FIRE ENGINEERING REPORT

North Sydney Public School

Project	North Sydney Public School
Title	Fire Engineering Report
Client	Taylor Construction Group Pty Ltd
Report No.	210557-FER01
Revision	A
Revision Date	17 June 2022
Prepared By	LCI Consultants Sydney Office L5 73 Miller Street, North Sydney NSW 2060 T 02 9157 0570
Author	Mark Thomas

Figure 17: Overview of Performance Solution

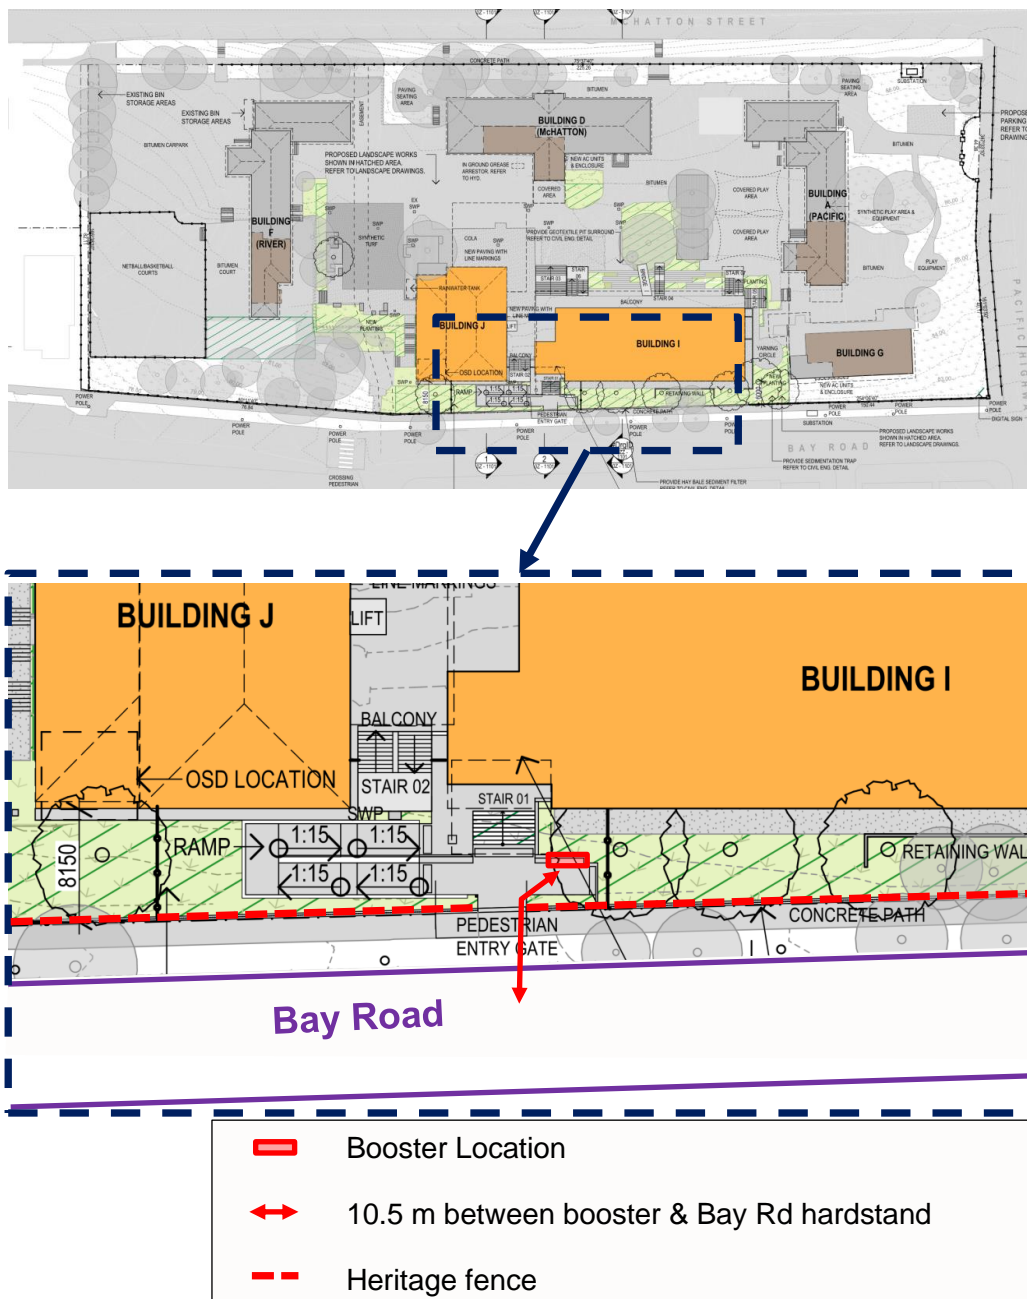
#	Performance Solution / FEBQ Section	FRNSW V02 Comments on FEBQ (01/08/2019)	LCI Response	Location in FER Where Addressed
2	Issue Number 12	FRNSW Comment: In principle support is provided subject to the analysis in the FER demonstrating compliance with the performance requirements of the NCC.	Performance Solution 1 demonstrates compliance with the relevant Performance Requirements of the NCC.	Section 5.

The new fire brigade booster assembly serving the proposed united buildings I & J will be located within 10.5 m of the hardstand at Bay Street. The location of the booster is understood to be driven by the limitations posed by the existing heritage fence and the location of proposed new opening within the fence (new entry gate).

The booster will be located within sight of the main entry from Bay Road which also serves as the hardstand. The site’s water supply will be from reticulated town main where the use of 65 mm hose connection on fire brigade booster inlets will be considered. Unlike large bore connections required for water storage which requires a rigid pipe, the 65 mm hose connection may be connected to flexible hose lengths up to 20 m.
